DIABLO CANYON INDEPENDENT SAFETY COMMITTEE

Report on

Fact-Finding Meeting at DCP on April 28 and 29, 2025

Najmedin Meshkati, Member, and Richard McWhorter, Consultant

Cross-Section of the DCPD Circulating Water Discharge Structure Showing the Approximate Locations of the ASW System Discharge Outlets in the Sides of the Structure (red dots; added by the FFT)

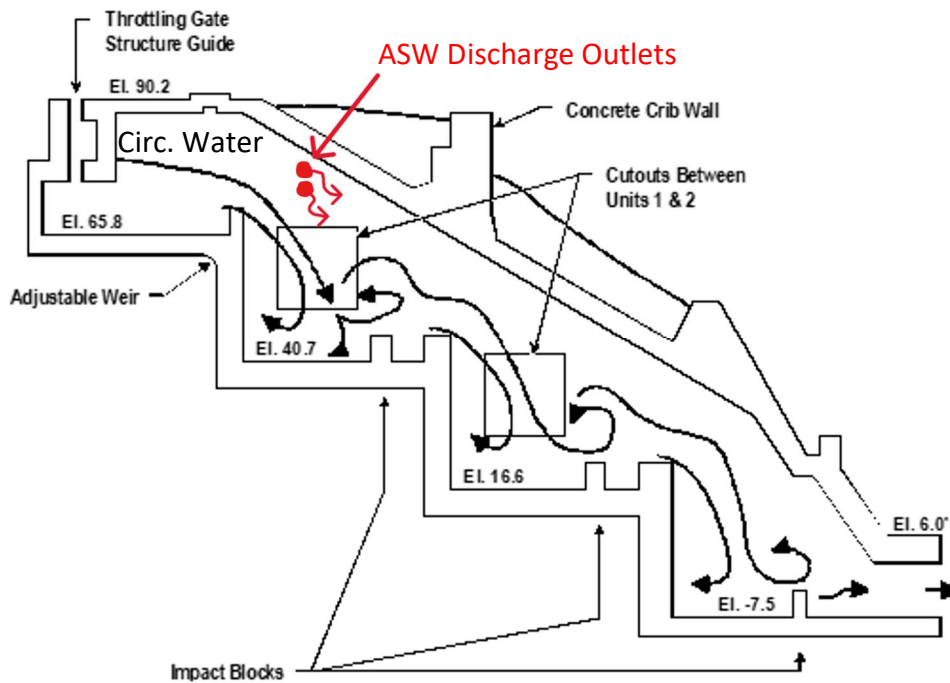
During this April meeting, the FFT explained to the PG&E staff the results of its January reviews and the possible scenario where a collapse of the Discharge Structure could block the ASW System discharge outlets. The FFT identified that the safety-related ASW System included two discharge headers per unit (four total) that discharged into the north and south sides of the non-safety related Circulating Water flow path inside the Discharge Structure. From two drawings provided by PG&E (59455 and 438093), the FFT concluded that the location where the ASW System discharge outlets entered the Discharge Structure was approximately as shown in red on the following sketch:

Mr. Conklin confirmed that the FFT's understanding of the configuration of the Discharge Structure and the location of the ASW System discharge outlets was correct. The FFT further explained that it believed that a collapse of the Discharge Structure in such a manner as to completely block flow was extremely unlikely, but it was possible. The possibility of this scenario (and its low probability) was also supported by similar statements made in the UFSAR. Given that the scenario was possible, the FFT inquired if such a scenario was included in the scope of the FLEX program analyses and FLEX guideline development. Mr. Conklin stated that there were no existing FLEX guidelines for this scenario and that further research would be required to understand if and how this scenario may have been addressed in the past analyses that formed the basis for the current FLEX Program. He agreed that this was a question worth researching and further review. The FFT concluded that a further review was warranted and recommended that PG&E review if and how the FLEX Program addressed the effects of a possible collapse of the Discharge Structure or other obstructions on the ASW System discharge flow path.

Recommendation to PG&E: PG&E should review if DCPD should have considered developing FLEX guidelines for providing an alternative discharge path for the Auxiliary Saltwater (ASW) System following a Beyond Design Basis event that may cause a collapse of the Discharge Structure or otherwise obstruct the ASW System discharge (P4/25FF-3.6). PG&E has accepted this recommendation and is working to address it under Notification 51283374.
